Access Compliance Report Public Rights-of-Way (Curb Ramps)

Main Street: HEMPSTEAD_ST Cross Street: KEMPTON_LN Location: SE

ADA ID: RPRK211021154647 Ramp Type: Type 4 - Parallel Initial Pass/Fail: Pass Overall Compliance: No Severity Score: 25

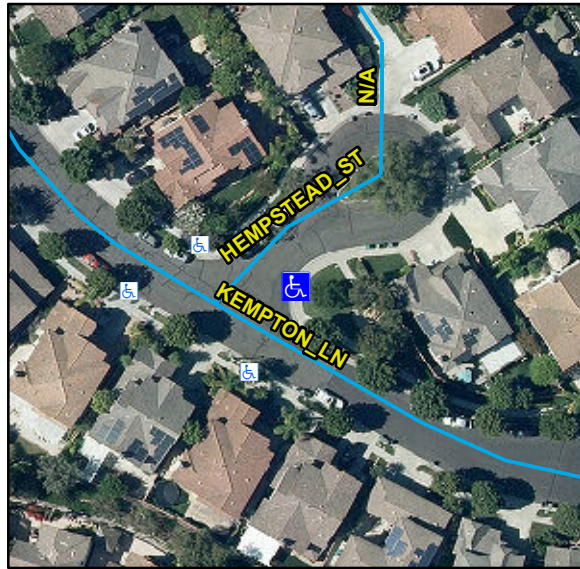
Compliance	Description	Data	Compliance	Description	Data
N/A	Ramp Length LT (in)	83	N/A	Ramp Length RT (in)	93
Yes	Ramp Width LT (in)	54	Yes	Ramp Width RT (in)	54
Yes	Ramp Run Slope LT (%)	6.6	Yes	Ramp Run Slope RT (%)	4.3
Yes	Ramp Cross Slope LT (%)	1	Yes	Ramp Cross Slope RT (%)	1.8
N/A	Landing Present	No	No	DWS Provided	No
N/A	Landing Length (in)	N/A	N/A	DWS Contrast	N/A
No	Landing Width (in)	N/A	N/A	DWS Length (in)	N/A
No	Landing Run Slope (%)	N/A	N/A	DWS Full Width	N/A
No	Landing Cross Slope (%)	N/A		DWS Offset Type	N/A
N/A	Landing Movement Obstructed?	No	N/A	DWS Offset Left (in)	N/A
	Landing Movement Type	N/A	N/A	DWS Offset Right (in)	N/A
N/A	Landing Shared	N/A			
N/A	Clear Space	Yes			
N/A	Clear Space To Crosswalk (in)	48			
N/A	Marked Crosswalk 1	No	N/A	Marked Crosswalk 2	No
	Crossing 1 Direction	NW		Crossing 2 Direction	SW
	Marked Crosswalk 1 Width (in)	N/A		Marked Crosswalk 2 Width (in)	N/A
N/A	Ramp Inside Crosswalk 1	N/A	N/A	Ramp Inside Crosswalk 2	N/A

Crossing 1 Slope (%)	6.8		Crossing 2 Slope (%)	1.1
	Crossing 1 Cross Slope (%)	2.6		Crossing 2 Cross Slope (%)	0.5
Yes	Gutter Ponding	No	No	Curb Slope	8.7
Yes	Gutter Lip Height (in)	0		Road Run Slope (%)	1
No	Gutter Run Slope (%)	6.6		Road Cross Slope (%)	5.2
Yes	Gutter Cross Slope (%)	0.5	No	Perpendicular Joint Present	No
Yes	Overall Surface Condition	Acceptable			
	Cross Gutter Present?	No		Spandrel Present?	No
	Replace Cross Gutter?	N/A		Replace Spandrel?	N/A

Remove & Replace Curb Ramp With Two New Directional Ramps or Equivalent. Remove & Replace Gutter.
